Serial No 14-036  
NSSL/MLC R0  
Docket No. 50-336  
License No. DPR-65

**DOMINION NUCLEAR CONNECTICUT, INC.**  
**MILLSTONE POWER STATION UNIT 2**  
**LICENSE AMENDMENT REQUEST FOR ADMINISTRATIVE CHANGES AND**  
**CORRECTIONS TO THE TECHNICAL SPECIFICATIONS**

**MARKED-UP TECHNICAL SPECIFICATION PAGES**

FIGURE 2-2-2 Local Power Density - High Trip Setpoint Part 2 ( $QR_2$  Versus  $Y_1$ )

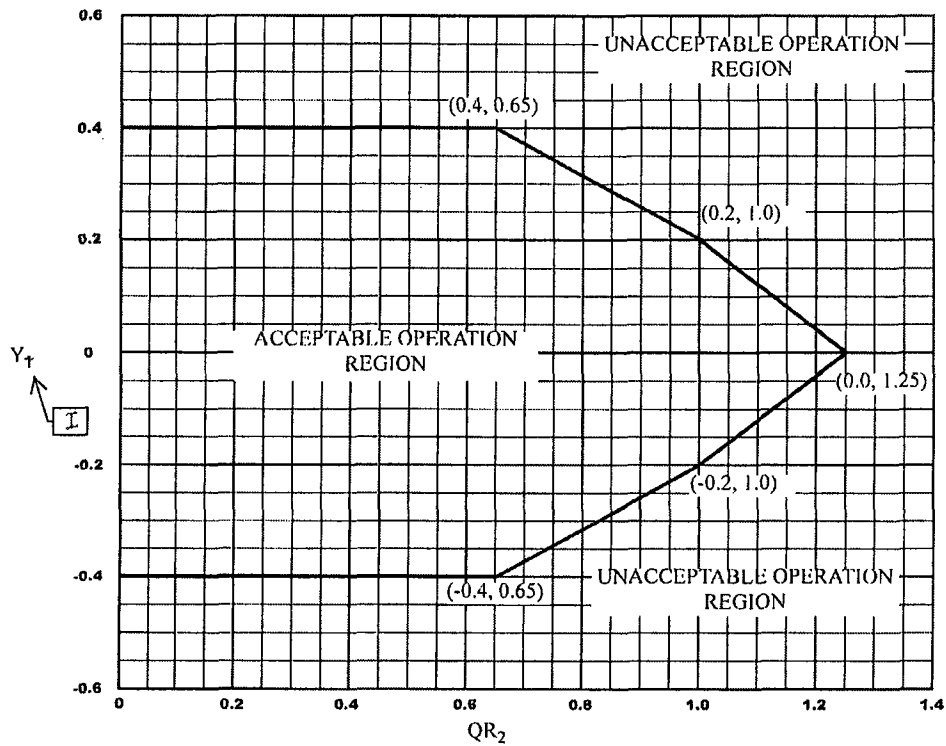
- b) The figure number on TS Page 2-7 for Figure 2-2-2, Local Power Density – High Trip Setpoint Part 2 ( $QR_2$  Versus  $Y_1$ ), is incorrect. The correct figure number is 2.2-2. This is a typographical error as the correct reference to this figure appears twice in TS Table 2.2-1.

- c) There are two locations in Figure 2-2-2 (to be relabeled as 2.2-2 as noted in (b) above) and four locations in Figure 2.2-3 where AXIAL SHAPE INDEX for the trip signals in the reactor protection system, is incorrectly labeled as "Y<sub>1</sub>" (Y sub 1). As shown in the Definitions section of the MPS2 TSs, the symbol for AXIAL SHAPE INDEX for the trip signals in the reactor protection system, is "Y<sub>I</sub>" (Y sub I).

- a) Delete TS index pages I through XVIII.
- b) Replace figure number "2-2-2" on TS Page 2-7 with "2.2-2."
- c) Replace "Y<sub>1</sub>" (Y sub 1) in two locations in Figure 2-2-2 (to be relabeled as 2.2-2 as noted in (b) above) and in four locations in Figure 2.2-3 with "Y<sub>I</sub>" (Y sub I).
- d) Replace "3.4.3.a and 3.4.3.b" in TS Table 3.3-11, ACTION 3, with "3.4.3.b and 3.4.3.c."
- e) Replace the word "begin" in TS Table 3.3-11, ACTION 5 with the words "be in."
- f) Revise TS 6.3.2, Facility Staff Qualifications, from:
